**TRUCK UTILITY MEDIUM (TUM)(HS) HT W/ VPK
BODY AND ASSOCIATED EQUIPMENT (SNATCH ALL VARIANTS)**

MODIFICATION INSTRUCTION NO. 22

SUBJECT: Seat belt cutters and stowage

Fig 1 Roof mounted seat belt cutters installation

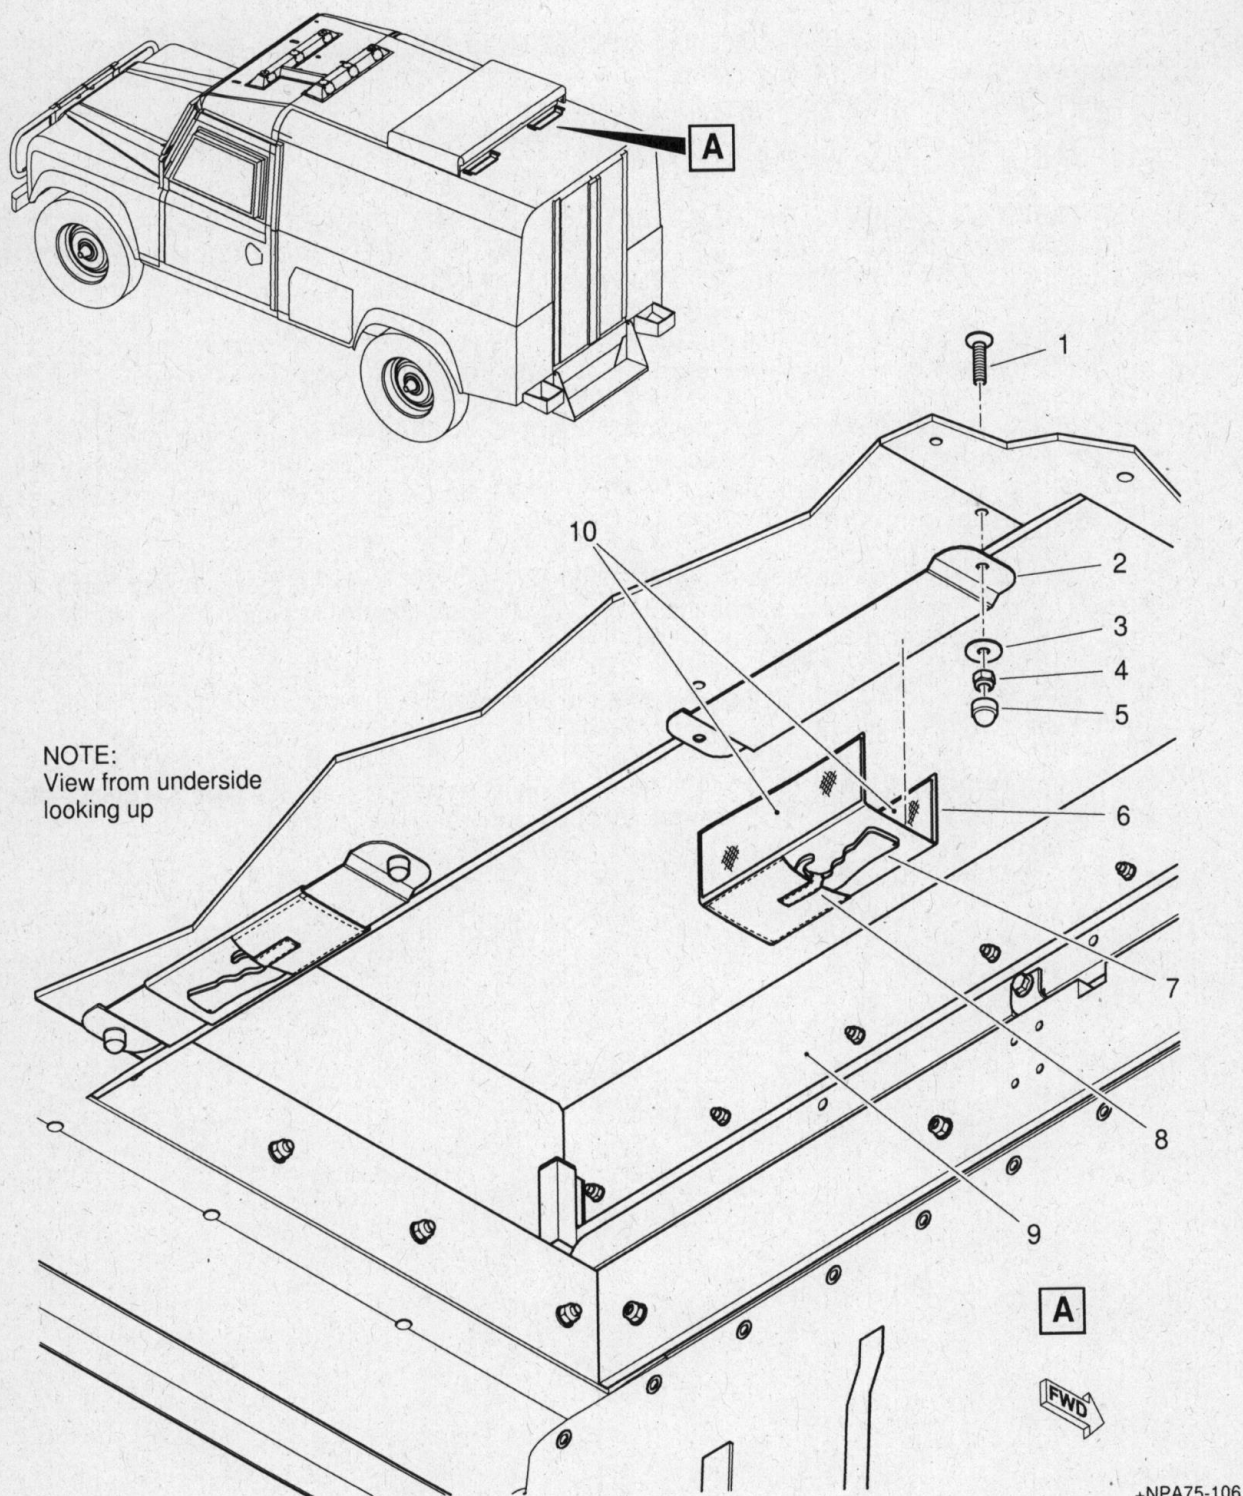
11.1 Identify the positions of the four hatch to roof mounting bolts, M8 (Fig 1(1)) at the rear of the hatch, which secure the hatch assembly (9) to the vehicle roof. Remove and discard the existing bolt caps, washers and nuts from the bolts. Leave the two bolts in position.

11.2 Remove the seat belt cutter (7) from the seat belt cutter in pouch (Item 1) and position the pouch (6) around the roof mounting bracket (Item 7)(2) in the orientation shown in Fig 1.

11.3 Place a roof mounting bracket complete with the pouch over the two RH roof mounting bolts, M8, and secure using two nyloc nuts (Item 4)(4) complete with plain washers (Item 5)(3). Torque tighten to 17 Nm. Place a new bolt cap, M8 (Item 6)(5) over each new nyloc nut on completion.

11.4 Once the roof mounting bracket is secured into position insert the seat belt cutter into the pouch, with the seat belt cutter handle facing the RH side of the vehicle. Secure in position using the Velcro patches (10) on the pouch.

11.5 Taking care not to injure fingers, ensure the seat belt cutter is secured in position within the pouch using the Velcro tab (8).

11.6 Repeat this procedure to install a seat belt cutter in pouch to the two LH roof mounting bolts, M8. Note the orientation shown in Fig 1, with the seat belt cutter handle facing the LH side of the vehicle.

Fig 2 Rear mounted seat belt cutters installation

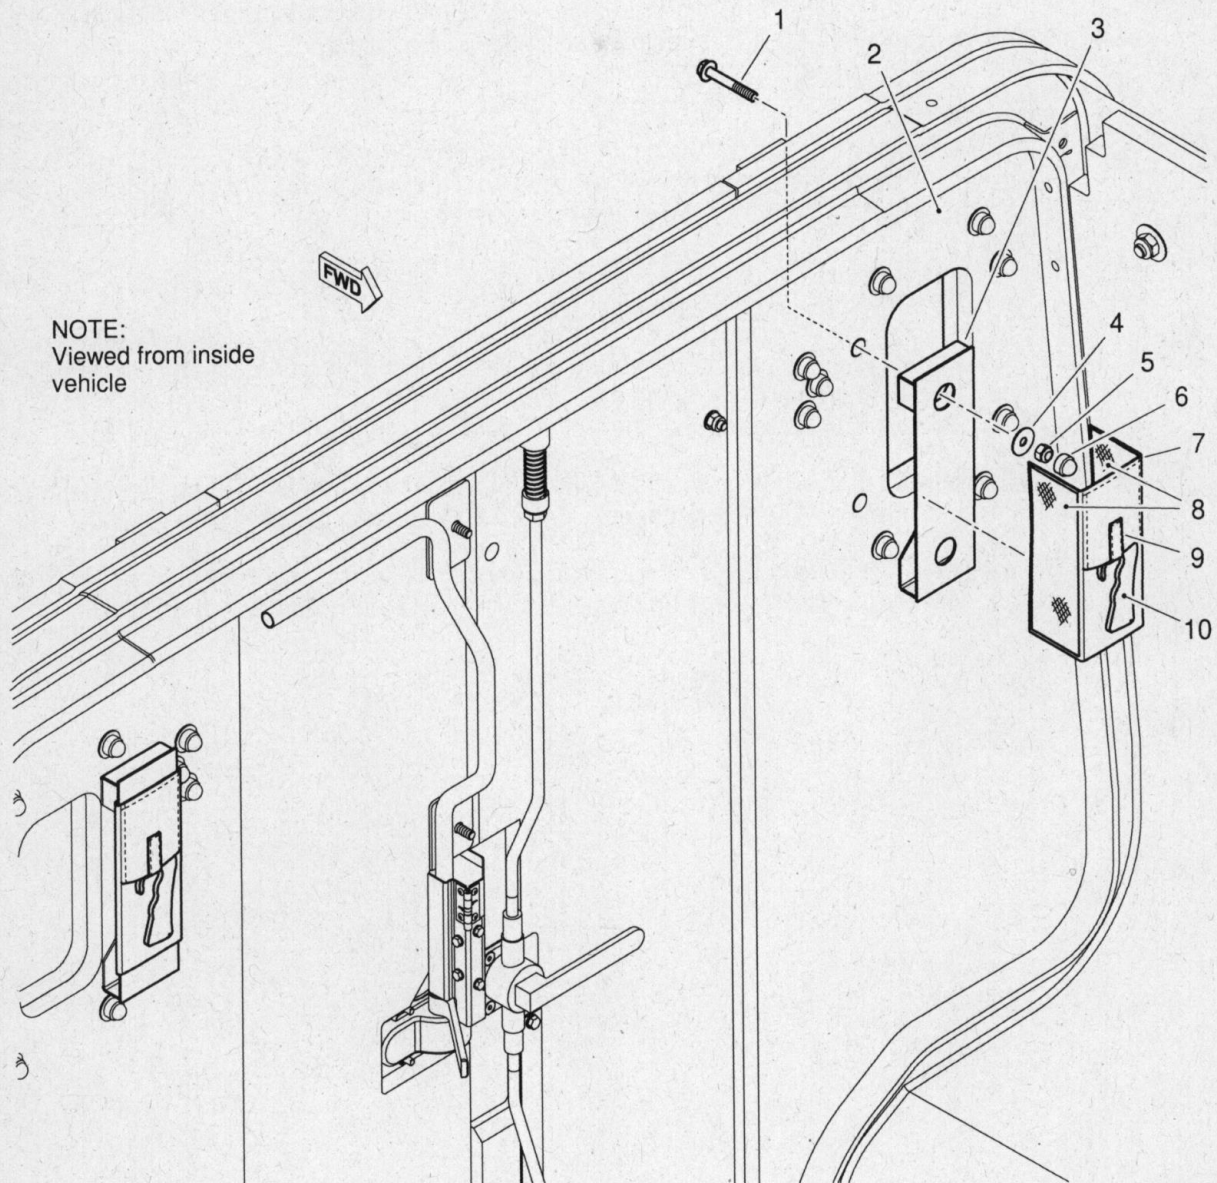
12.1 Identify the rear window mounting position in the LH vehicle rear panel (Fig 2(2)) and remove and discard the existing bolt caps, washers and nuts from the two inner rear window mounting bolts (1). Leave the two bolts in position.

12.2 Remove the seat belt cutter (10) from the seat belt cutter in pouch (Item 1) and position the pouch (7) around the rear mounting bracket (Item 12)(3) in the orientation shown in Fig 2.

12.3 Place a rear mounting bracket over the two inner window mounting bolts, in the position of the removed nuts, and secure using two nyloc nuts (Item 9)(5) complete with plain washers (Item 10)(4). Torque tighten to 17 Nm. Place a new bolt cap, M8 (Item 11)(6) over each new nyloc nut on completion.

12.4 Once the rear mounting brackets are secured into position insert the seat belt cutter into the pouch, with the seat belt cutter handle facing downwards. Secure in position using the Velcro patches (8) on the pouch.

12.5 Taking care not to injure fingers, ensure the seat belt cutter is secured in position within the pouch using the Velcro tab (9).

12.6 Repeat this procedure to install a seat belt cutter in pouch to the RH vehicle rear panel. Note the orientation shown in Fig 2, with the seat belt cutter handle facing downwards.

Fig 3 Sun visor seat belt cutters installation

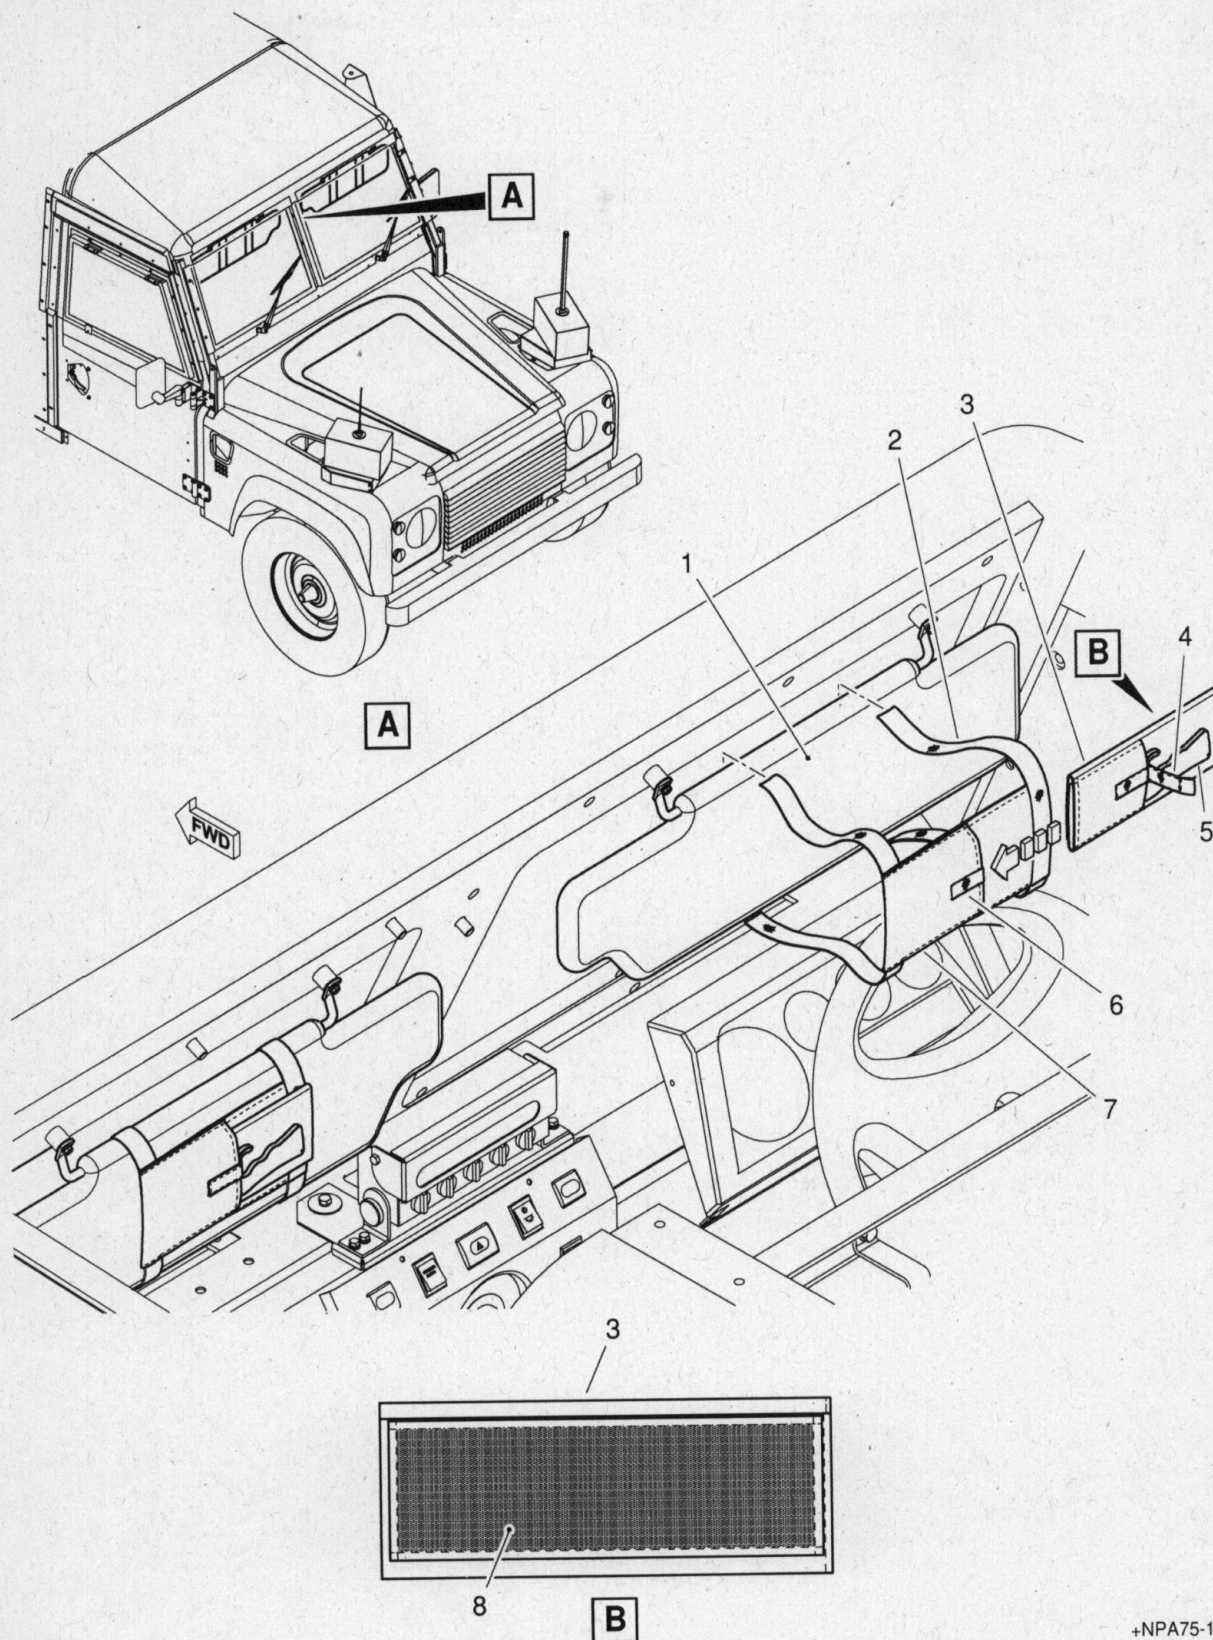
13.1 Identify and lower the RH sun visor (Fig 3(1)).

13.2 Fit the sun visor pouch (Item 13)(7) to the centre of the RH sun visor and secure in position using the two fastening legs (2), which have Velcro material incorporated.

13.3 Identify a seat belt cutter in pouch (Item 1)(5 and 3) and fold so that the Velcro material (8) of the pouch (3) is facing outwards, as shown in Fig 3.

13.4 Insert the seat belt cutter in pouch into the sun visor pouch in the orientation shown in Fig 3, with the handle of the seat belt cutter facing the RH side of the vehicle. The Velcro material (8) on the rear of the pouch will now engage with the Velcro material on the RH fastening leg (2).

13.5 Taking care not to injure fingers, ensure the seat belt cutter is secured in position within the pouch using the Velcro tab (4), which engages with the sun visor pouch Velcro strip (6).

13.6 Repeat this procedure to install a sun visor seat belt cutter to the LH sun visor. Note the orientation shown in Fig 3, with the seat belt cutter handle facing the RH side of the vehicle.
